Appl. No. 10/046,066

AQUA-005

Amdt. Dated October 29, 2004

Reply to Office Action of July 29, 2004

FIG. 2C

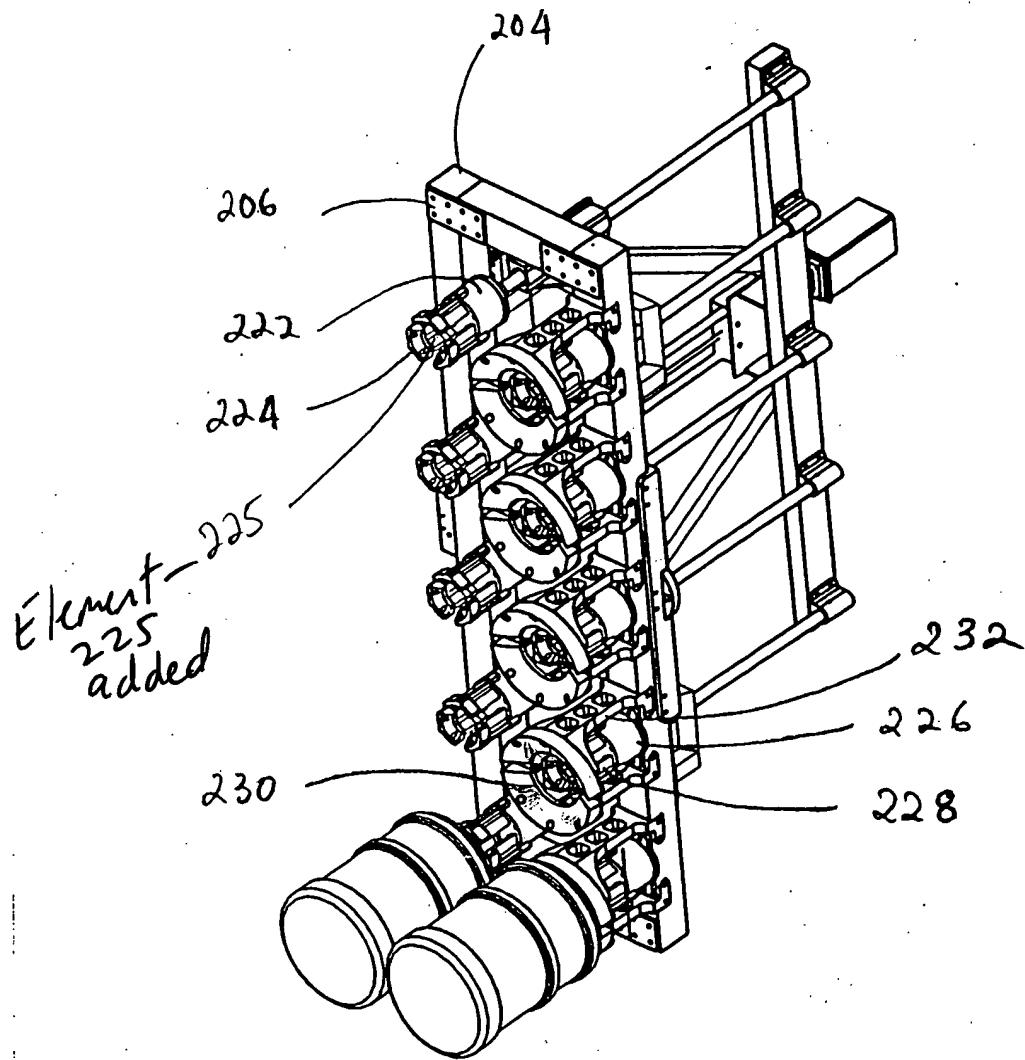
The drawings were objected to pursuant to 37 CFR 1.83 (a) for not showing the following claimed elements: the “pressure sensor”; the “interface”; and a “motorized base”.

Fig. 2c has been amended to show the pressure sensor (225). The specification has previously been amended to recite the correct reference number for the pressure sensor.

FIG. 3

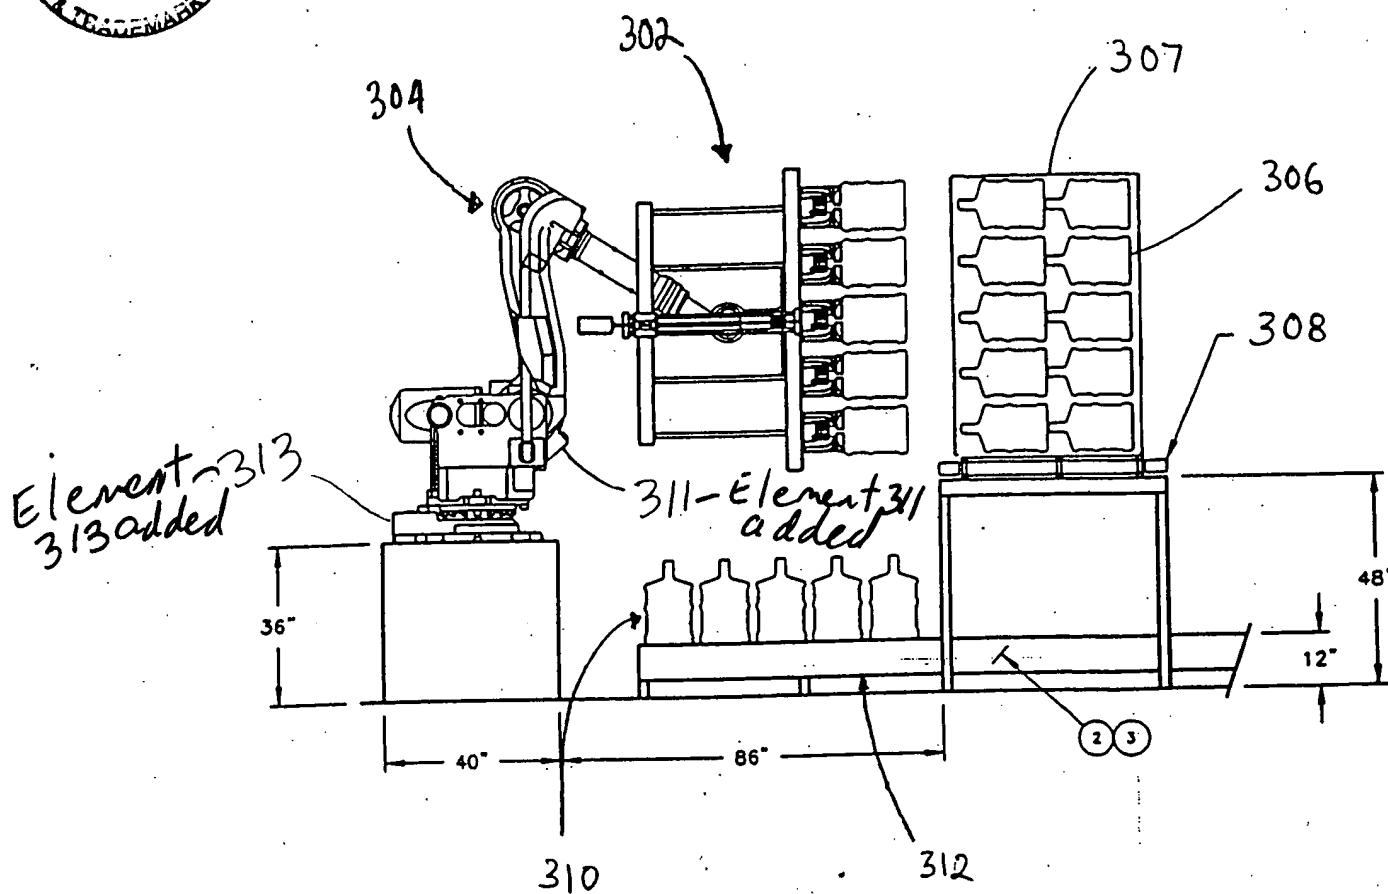
Fig. 3 has been amended to show the interface (311) and the motorized base (313). Replacement sheets for Figs. 2c and 3 are attached herewith.
